October 24, 2005

Addendum 1
Feasibility Study Addendum
Ross Island Sand & Gravel Company
Portland, Oregon
GeoDesign Project: PerkinsCoi-8-01-01

On behalf of the Ross Island Sand & Gravel Company, GeoDesign, Inc. is pleased to submit this addendum to our August 2, 2005 Feasibility Study as requested in the Oregon Department of Environmental Quality's (DEQ) September 27, 2005 comment letter. In the September 27 letter, DEQ approves the Feasibility Study, but requests additional detail on how the proposed remedial actions described in the Feasibility Study will be integrated with the existing Reclamation Plan for the site. Additionally, the letter requests clarification regarding select remedial action areas and other minor clarifications to the text. The additional detail and clarifications that DEQ requested are presented in numerical order and correlate with each DEQ comment.

FIGURE 1

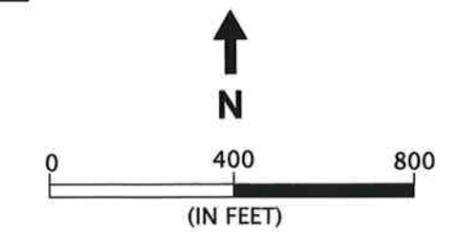
The surveyed data and the depth to surface sediment measurements were used to create a total of four cross sections (A-A', B-B', C-C', and D-D'), the locations of which are shown on Figure 1. These cross sections graphically indicate how much of the required cap thickness has already been achieved through existing reclamation fill, how much additional cap thickness will be achieved with planned reclamation fill, and how much material will need to be imported in addition to this to meet the estimated minimum cap thickness of 3 feet.

FIGURE 2

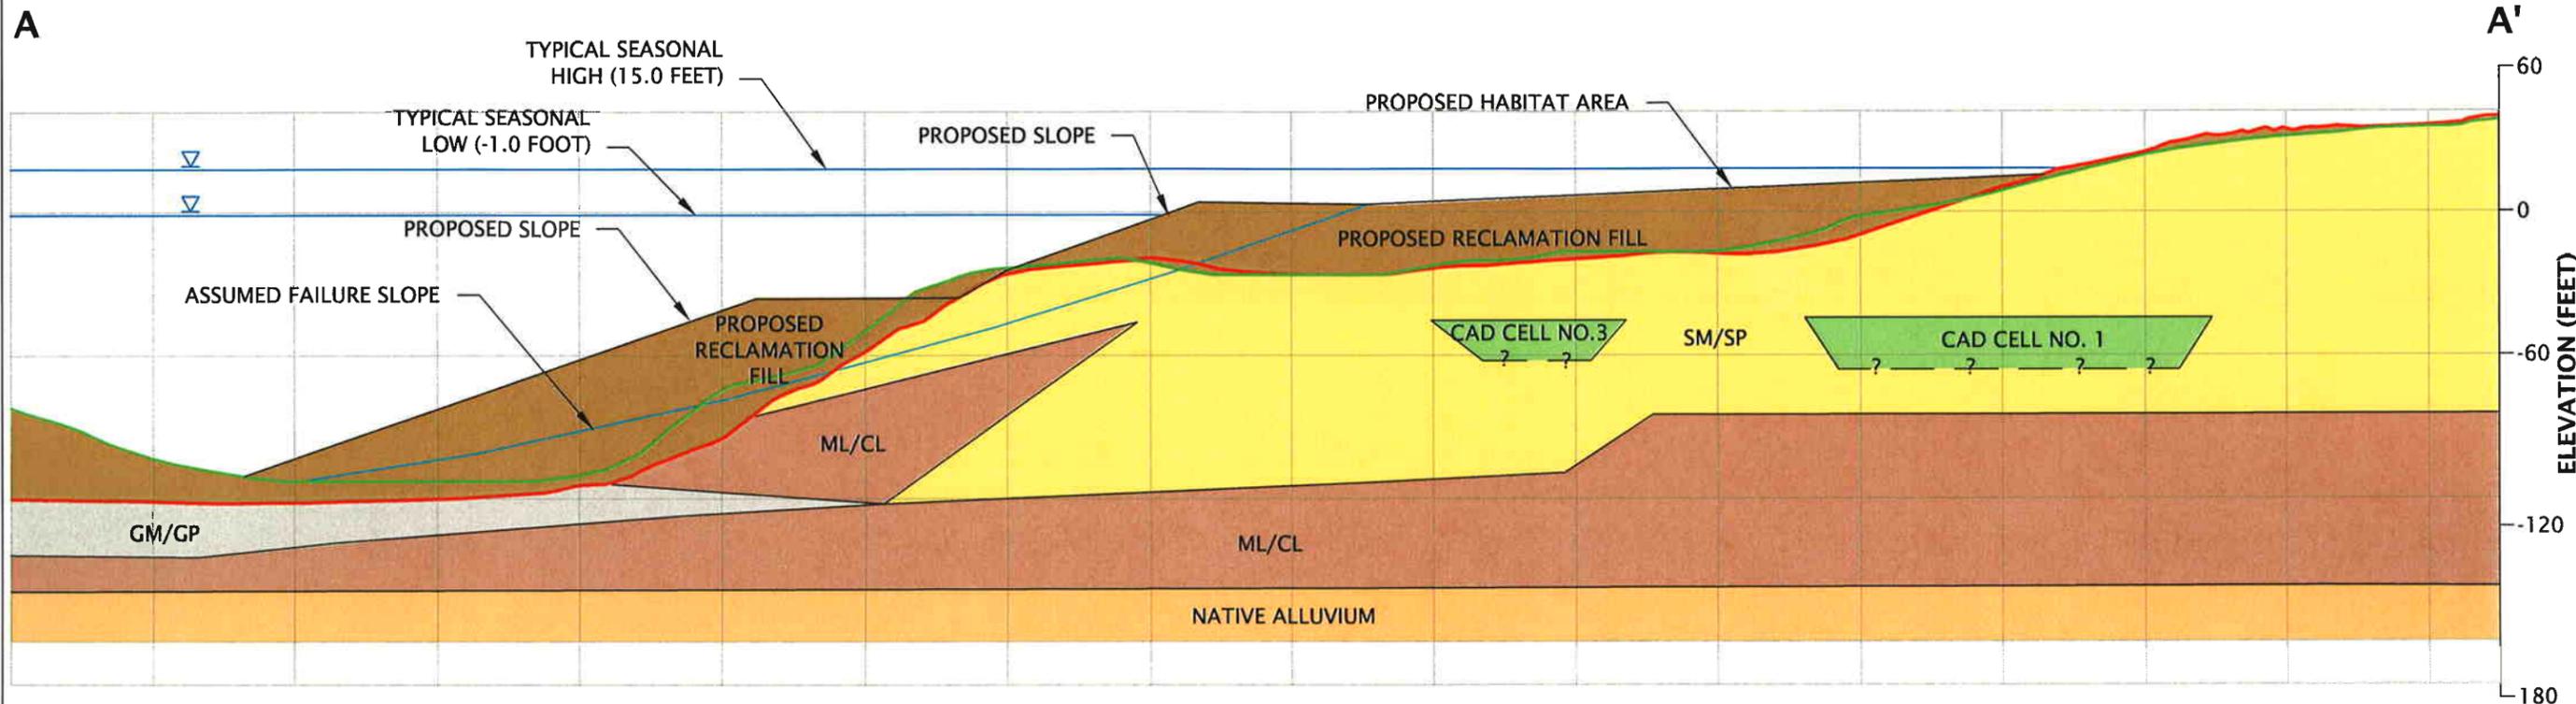
As shown on Cross Section A-A' (Figure 2), some minor fill has accumulated in certain areas, but in general, this area appears very similar to the conditions that existed at the time of the 2001 bathymetric and topographic survey data. The proposed fill will provide at least a 3-foot cap over the remedial action areas (Figure 6).

FIGURE 3

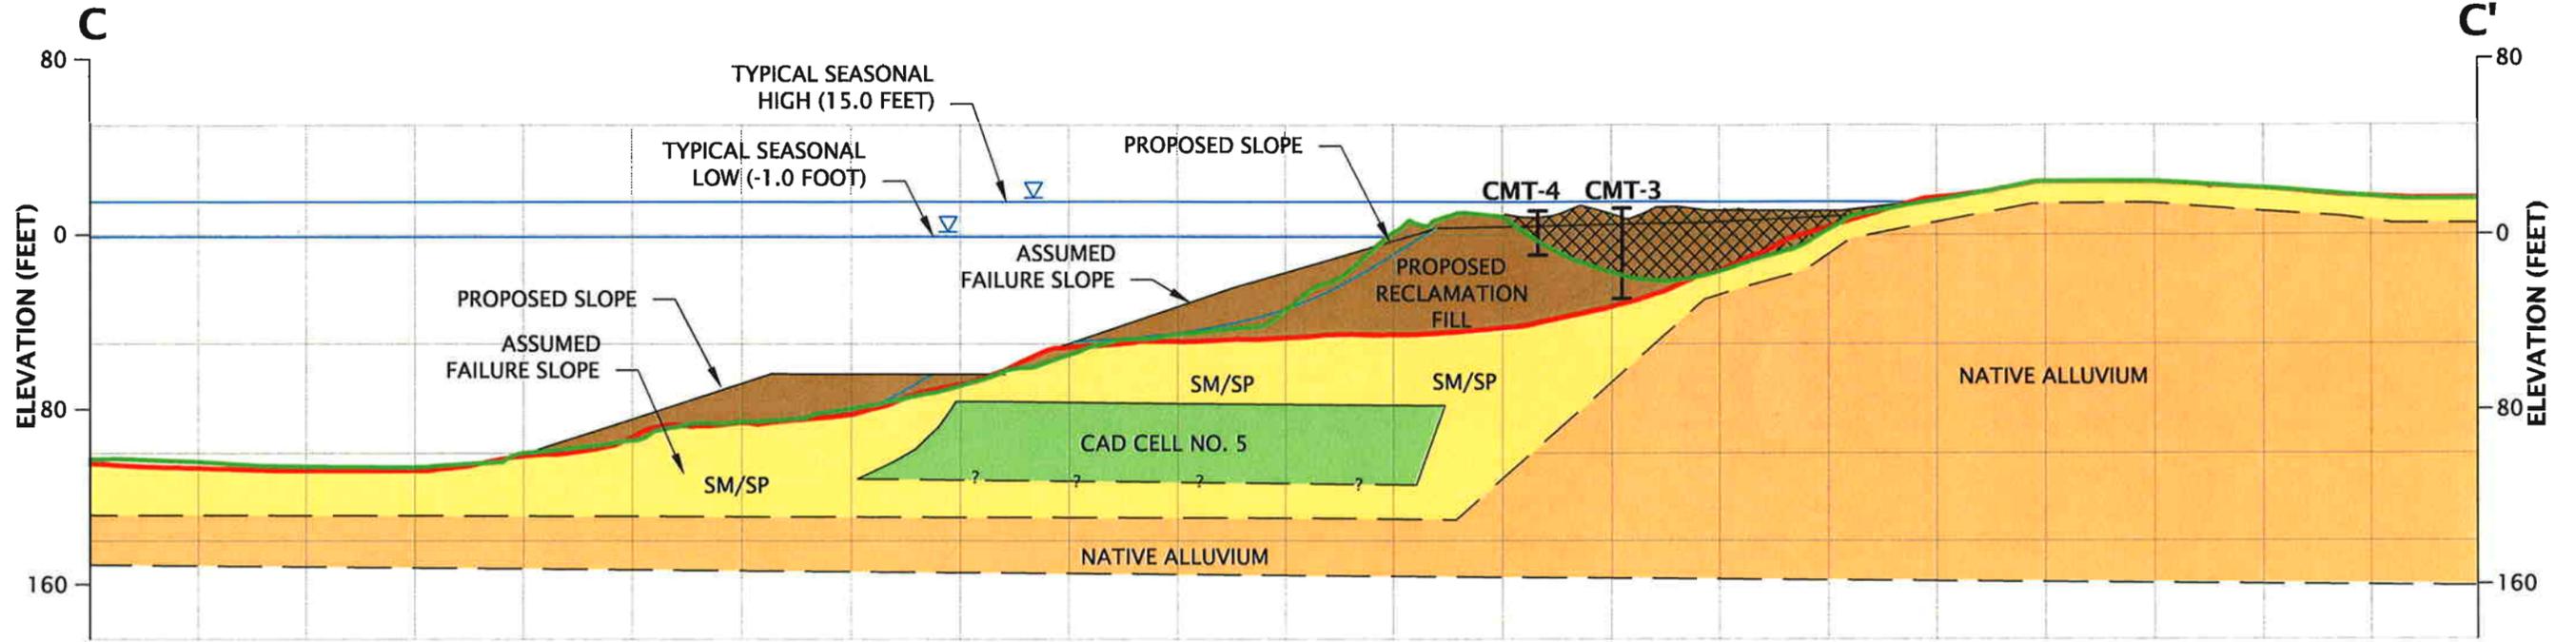
As shown on Cross Sections B-B' (Figure 3) and C-C' (Figure 4), as much as 15 and 50 feet of fill, respectively, has been placed along the shoreline in these areas based on the 2001, 2003, and 2005 topographic and bathymetric survey data. In general, the conditions toward the lagoon in these areas are very similar to the conditions that existed at the time of the 2001 bathymetric and topographic survey data. The proposed fill will provide at least a 3-foot cap over the remedial action areas (Figure 6).

FIGURE 5

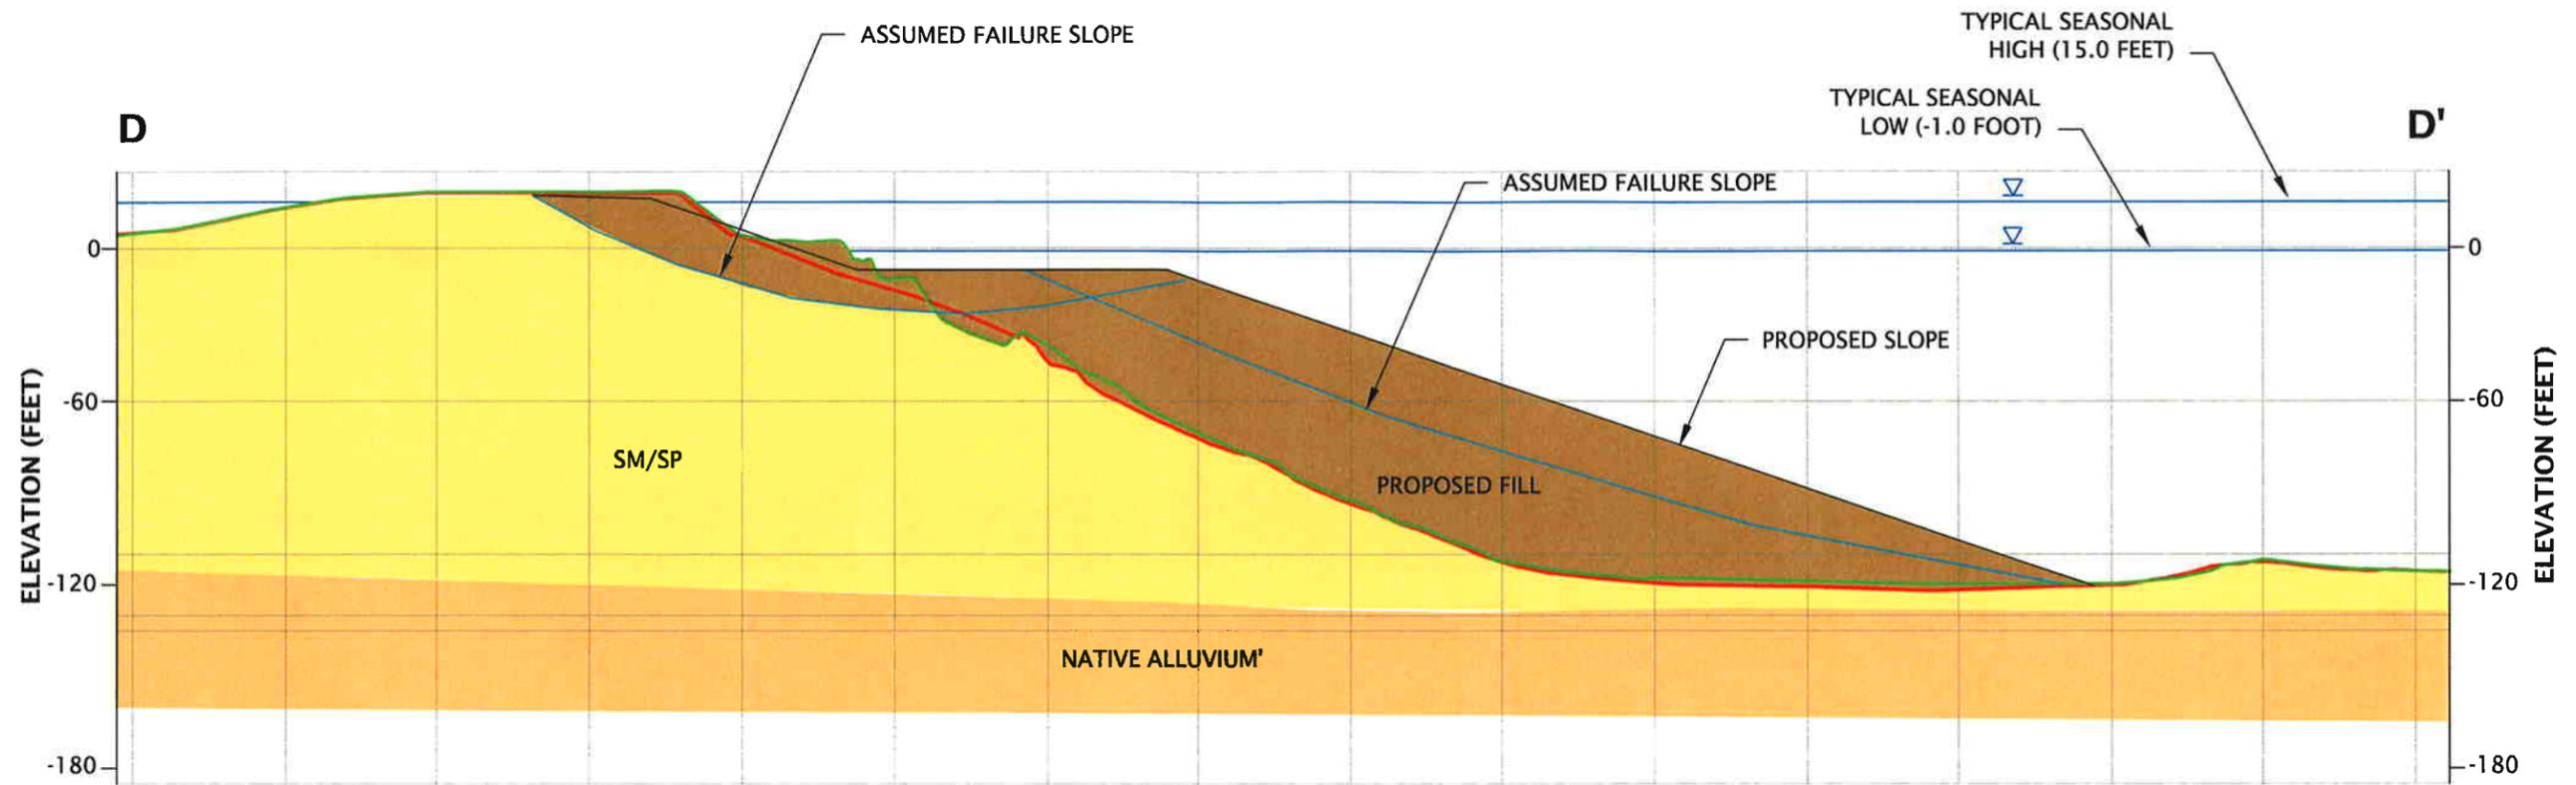
As shown on Cross Section D-D' (Figure 5), some minor fill has accumulated in certain areas, but in general, this area appears very similar to the conditions that existed at the time of the 2001 bathymetric and topographic survey data. There are no proposed remedial action areas in this area (Figure 6).

FIGURE 6

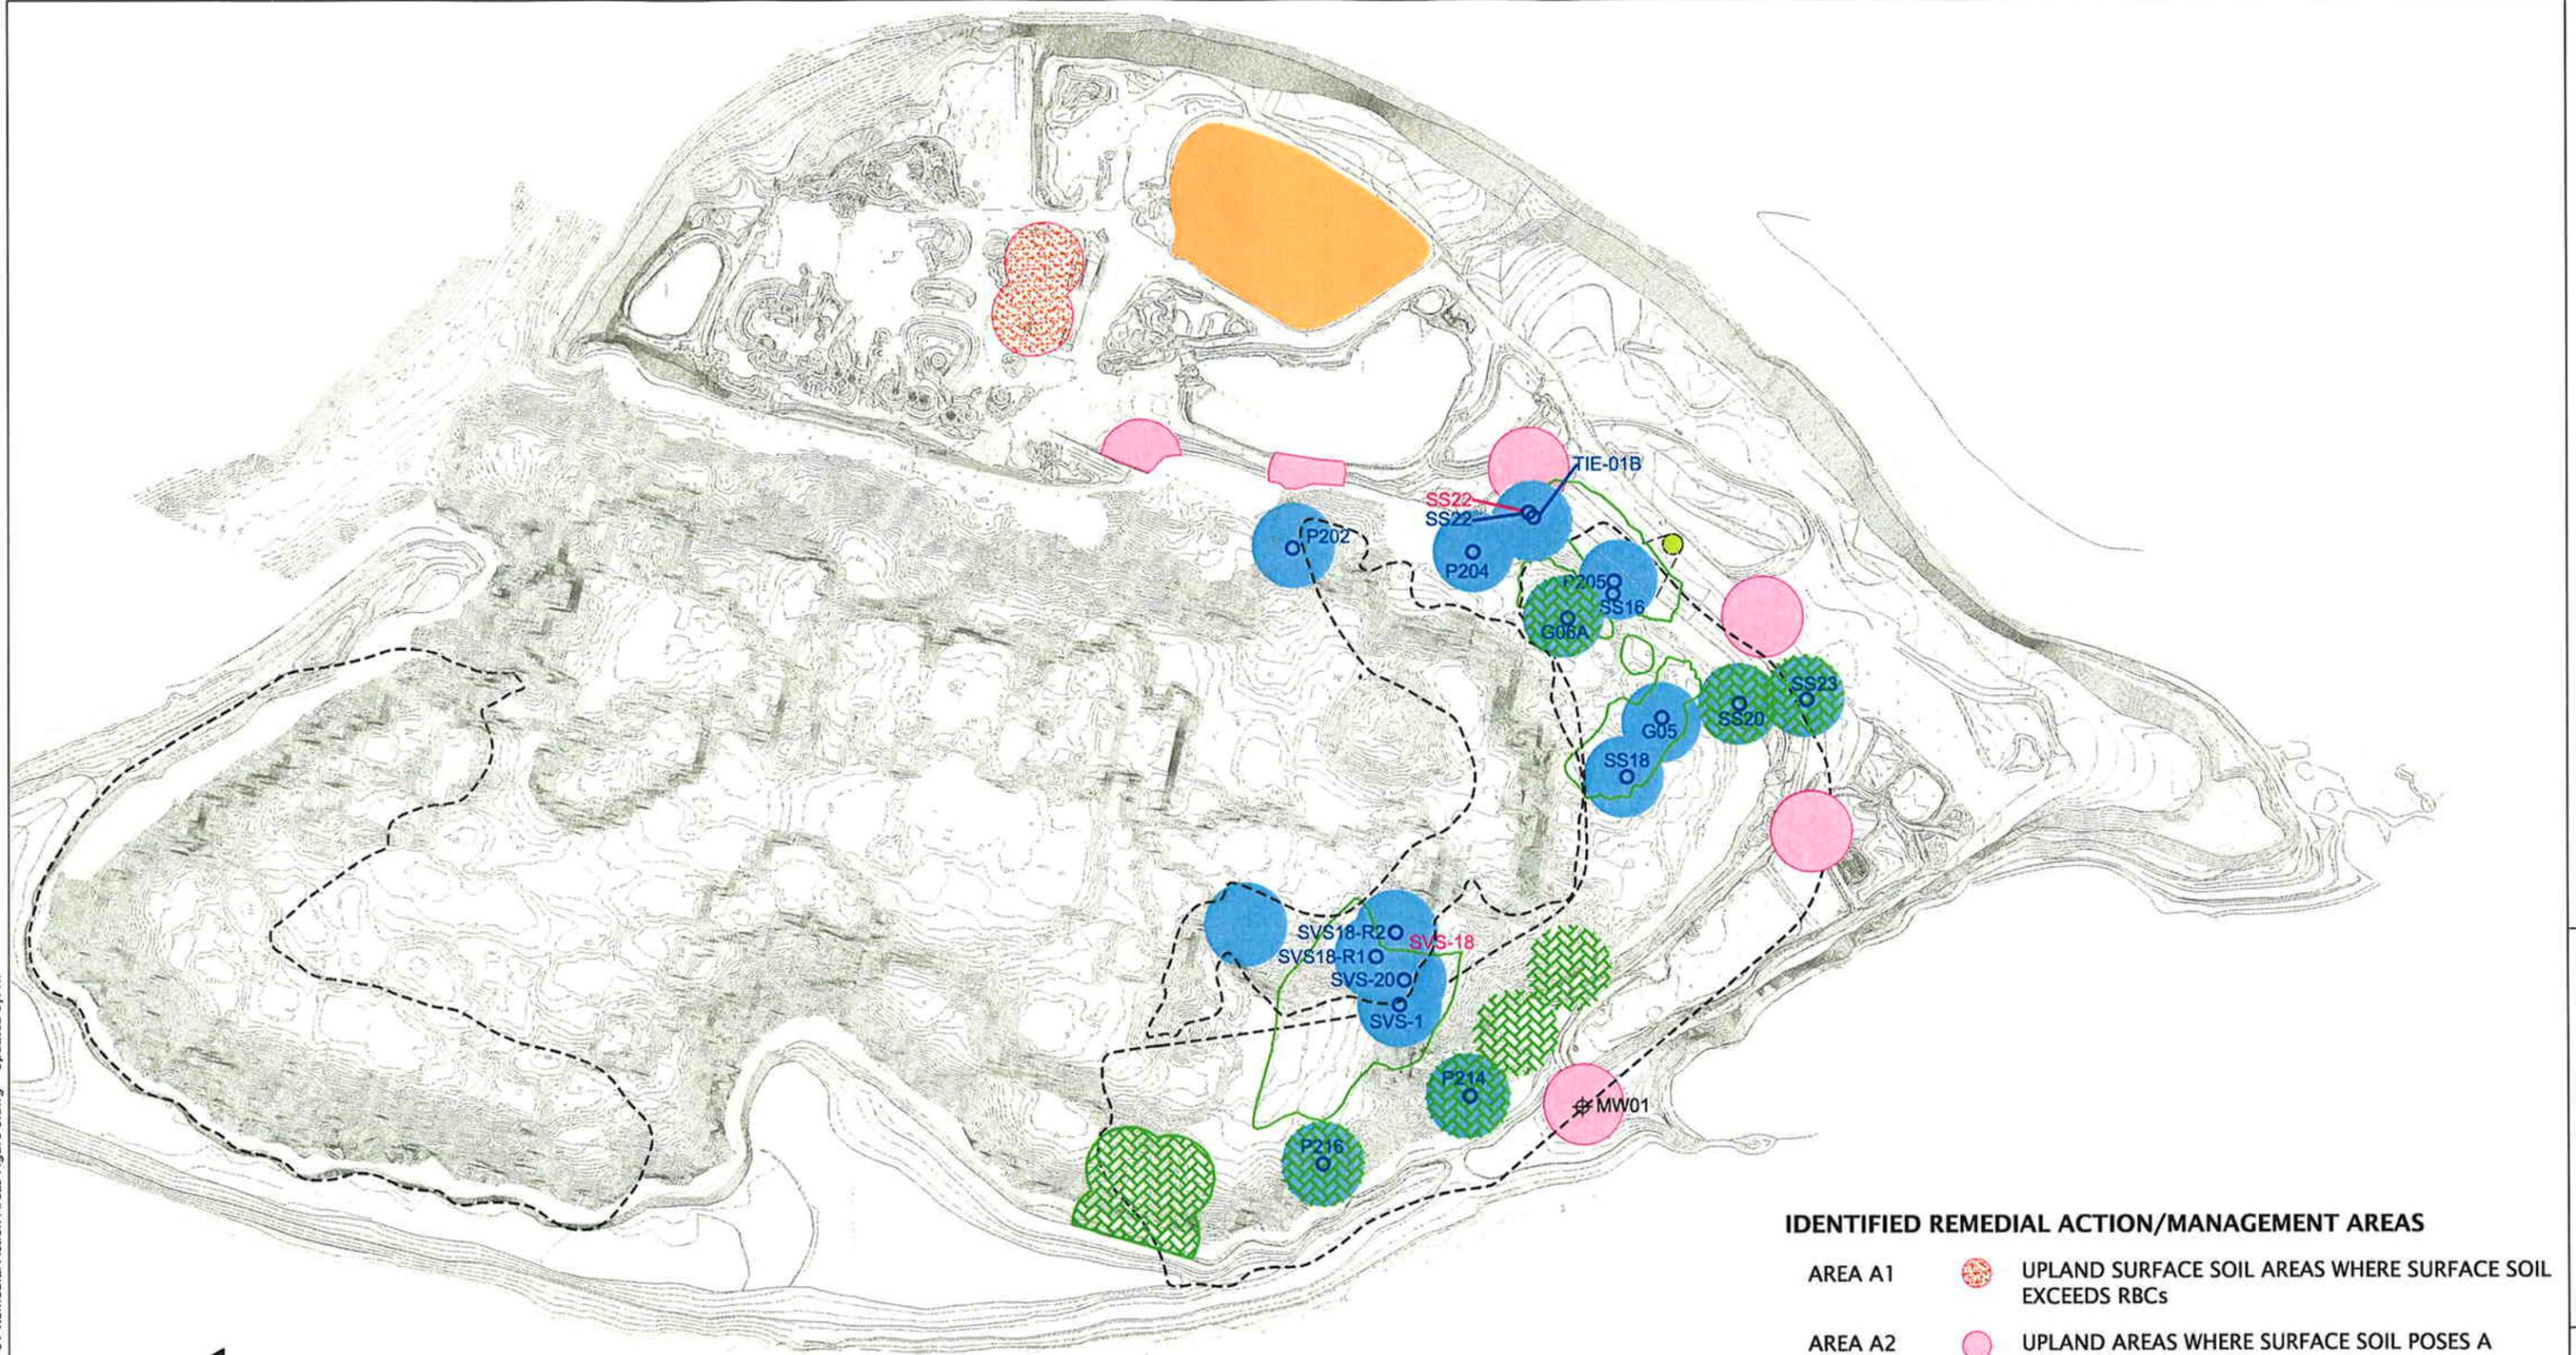
1. Figure 6 (attached) presents the identified remedial action/management areas presented in the Feasibility Study. Hot spots have been identified for portions of Area D and all of Areas B and F. We utilized AutoCAD 2006 to calculate the aerial extents of each of the in-water areas planned to be capped (Areas D and E). The volume of impacted surface sediment was calculated by multiplying the aerial extent by the vertical depth of the impacted surface sediment (0.3 foot). The volume of required cap material was calculated by multiplying the aerial extent by the minimum thickness of the proposed cap (3 feet). Based on the aerial extents, the total calculated volume of impacted surface sediment at Areas D and E are approximately 4,600 and 3,500 cubic yards, respectively.

- Figure 6 (attached) has been revised to indicate that there are no cleanup areas in the central lagoon.
- Tables 16 and 17 (attached) have been revised as requested in DEQ's September 27 letter. Also attached is the revised cost table for Area F that takes into account the total volume of material that would need to be removed above the confined aquatic disposal (CAD) cells (estimated at approximately 250,000 cubic yards) prior to removing the impacted material. The volume estimate takes into account the varying thickness of clean material existing over the CAD cells and the amount of material required to be removed to maintain a 1 horizontal to 1 vertical slope from the surface of the sediment to the base of the impacted CAD cell.
